Project  
Adaptation and Refurbishments

Drawing Title:  
**Ground Floor Layout  
As Approved Planning Certificate**

Drawing Number:  
BR-09-1013-05

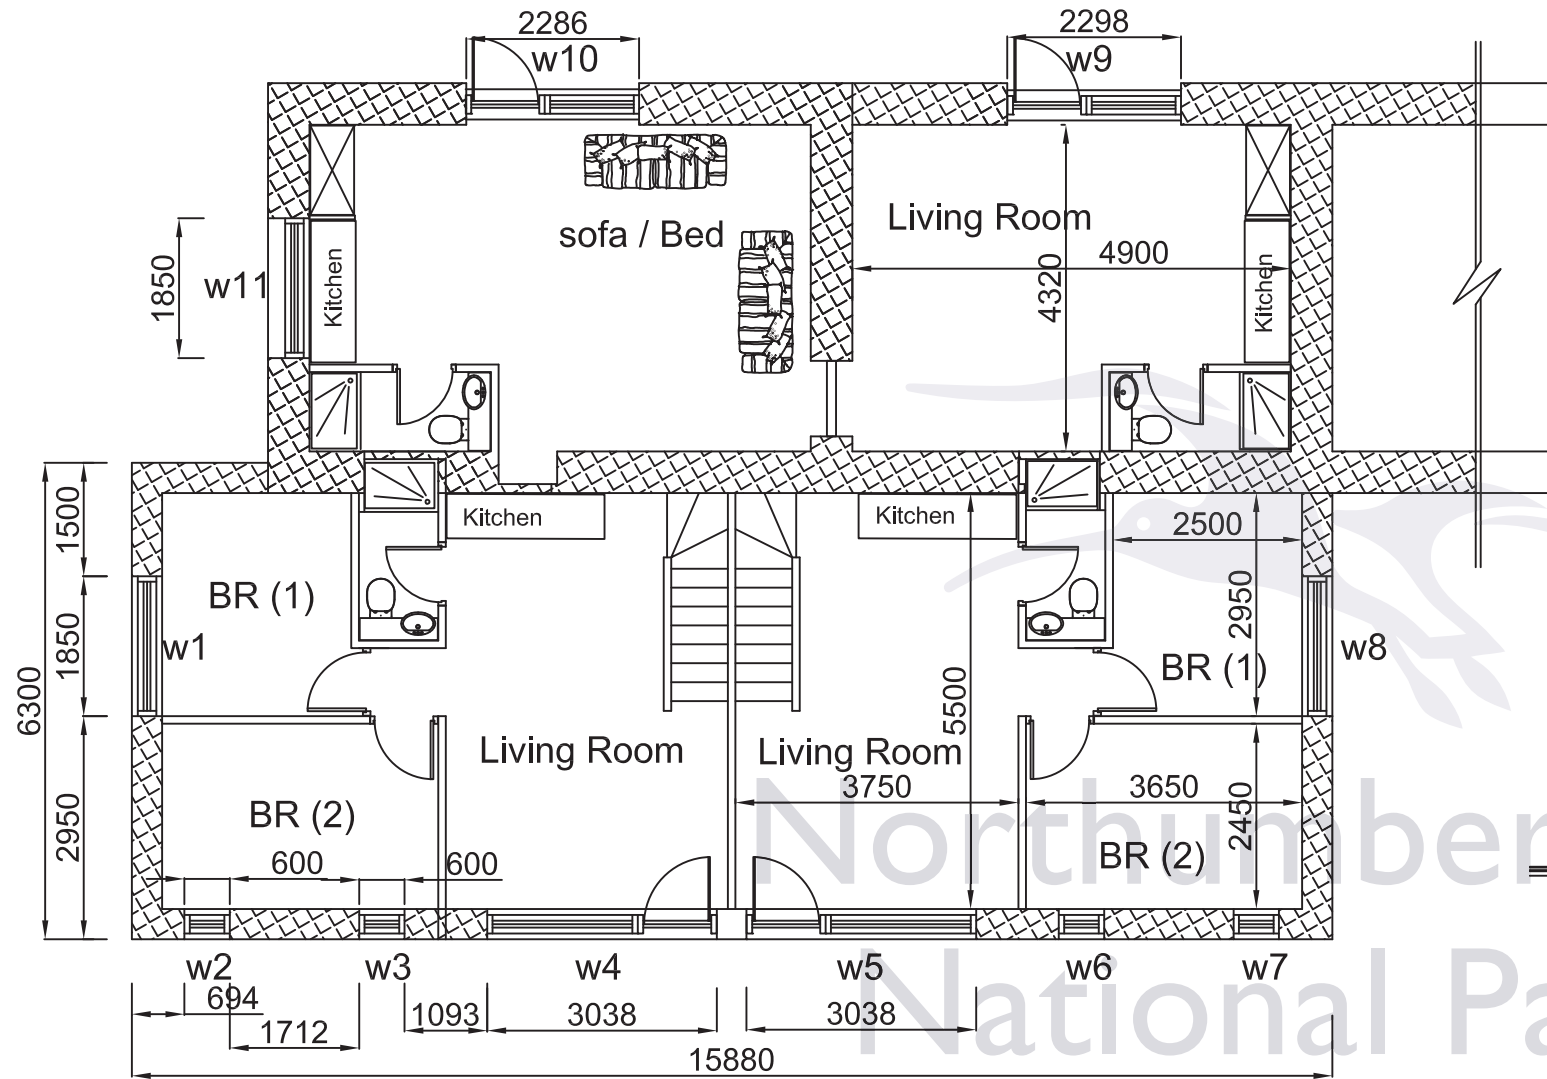
These door and windows, top should be 2250mm from existing concrete floor. (this is from concrete to underside of new Lintel)
